VERIFICATION OF CORRECTIVE ACTION AND CLOSURE OF DEFICIENCY REPORT
(DR) YM-96-D-074 RESULTING FROM OFFICE OF QUALITY ASSURANCE (OQA)
SURVEILLANCE YMP-SR-96-019 OF SANDIA NATIONAL LABORATORIES

PERFORMANCE/DEFICIENCY REPORT

Figure 1. PPV vs. Scaled Distance ($R/W^{1/2}$) for TTF AOD

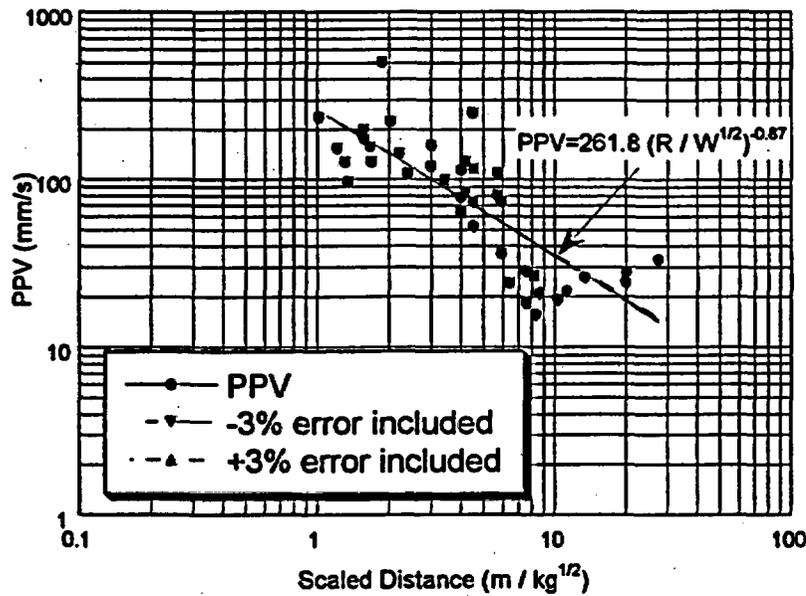
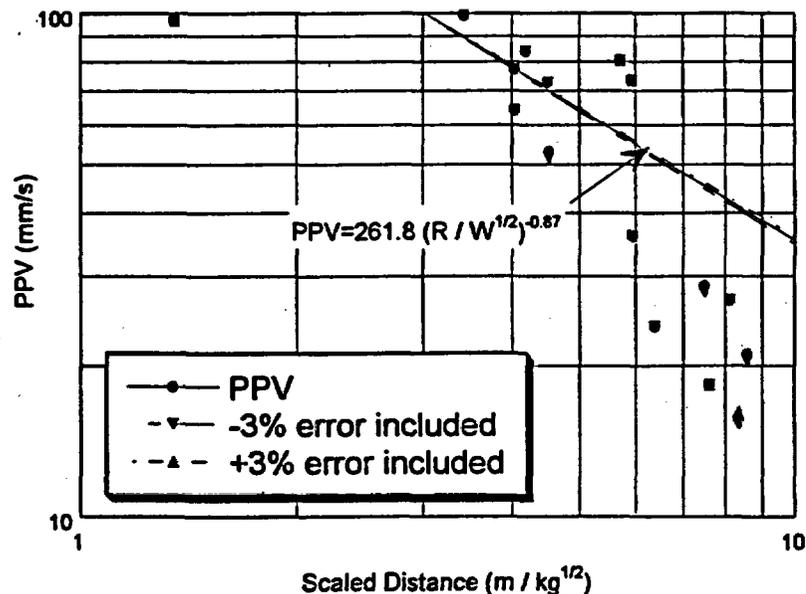
3. The effect of this expected error on the seismic results is minimal due to the following reasons. First, the seismic results are typically plotted in scaled distance vs. charge weight in logarithmic scale. Based on SNL-PSL calibration results an expected error range of +/-3% for our measure frequency range (40 to 90 Hz) was applied to our far-field data. The results show that inclusion of possible errors in the reported data is insignificant on our PPV vs. Scaled distance relationship (see Figures 1 and 2). Second, these measurements are conducted in a rock mass which generally possesses a large degree of variabilities in behavior and properties. This results in a certain scatter of the seismic data which is significantly greater than the measurement error inherent in the seismograph. Thus this instrument error is absorbed within the natural variability of the rock mass properties which results in a minimal impact on the final attenuation relationship.
